NUCLEAR FUEL MANAGEMENT DEPARTMENT
NUCLEAR DESIGN INFORMATION TRANSMITTAL

NDIT No. NFM9900022
Seq. No. 1
Page 1 of 15

Subject Braidwood Unit 2 Cycle 8 Core Operating Limits Report in ITS Format and W(z) Function

CORE OPERATING LIMITS REPORT (COLR) for BRAIDWOOD UNIT 2 CYCLE 8

Figure 2.5.1.a: K(Z) - Normalized Fq(Z) as a Function of Core Height (Assembly BU \leq 4000 M³/D/MTU)

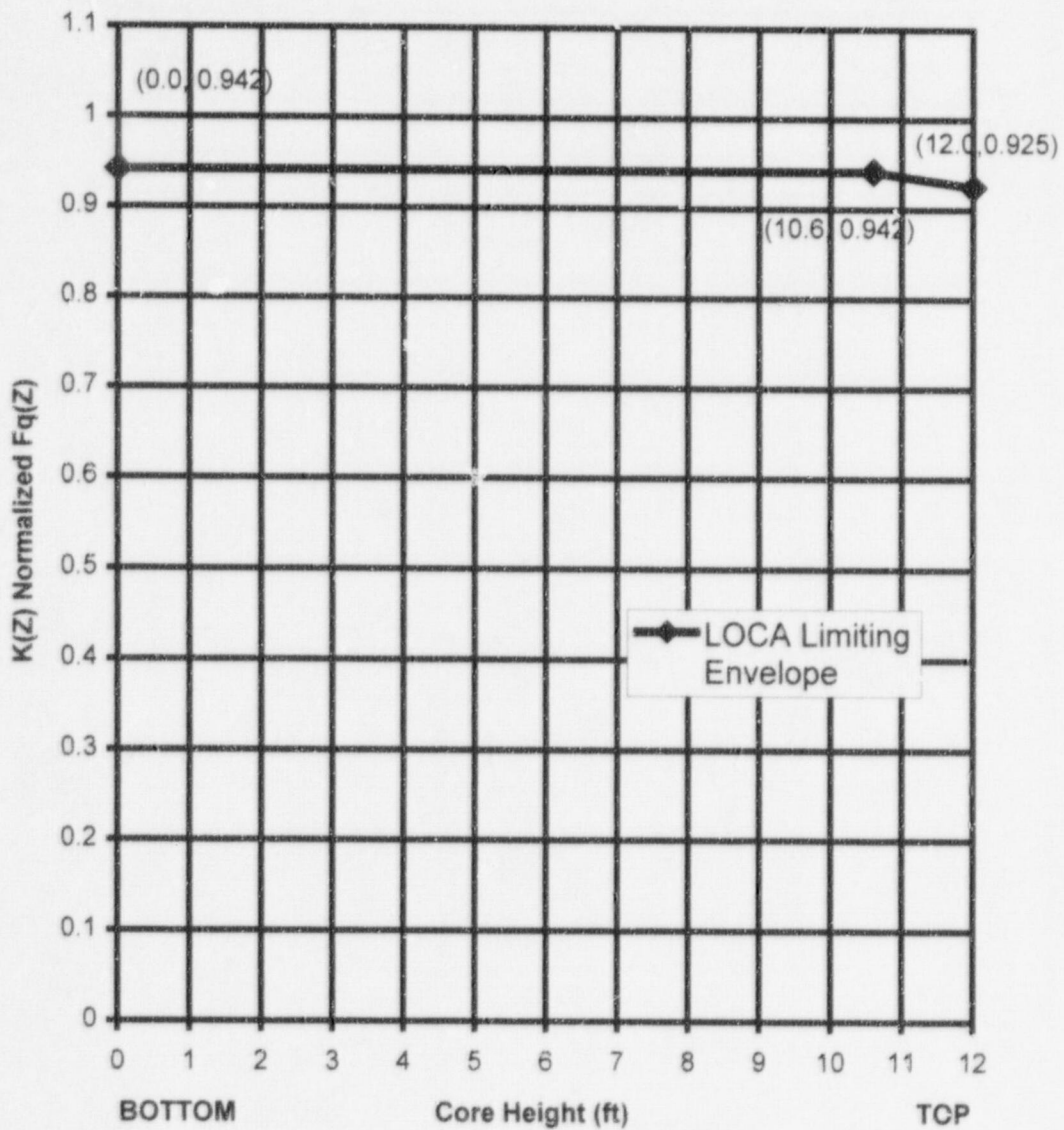
Purpose of Information: Sequence 1 of this NDIT supersedes NDIT NFM9900022, Seq. 0. This COLR incorporates the ITS format and W(z) function. Sequence 1 incorporates a revised K(z) curve for assembly average burnup ≤ 4000 MWD/MTU due to the recent issue on the LOCBART code discrepancy affecting LBLCCA analysis. Braidwood Station is requested to perform an Independent Technical Review (ITR) of this document. Upon completion of the ITR, Braidwood Station is to transmit the COLR portion to the Nuclear Regulatory Commission. Please provide NFM (Rob Lee) with a copy of Braidwood Station's completed ITR and COLR submittal to the NRC.

$K(Z)$ for assembly average burnup > 4000 MWD/MTU is provided in Figure 2.5.1. $K(Z)$ for assembly average burnup ≤ 4000 MWD/MTU is provided in Figure 2.5.1.a.
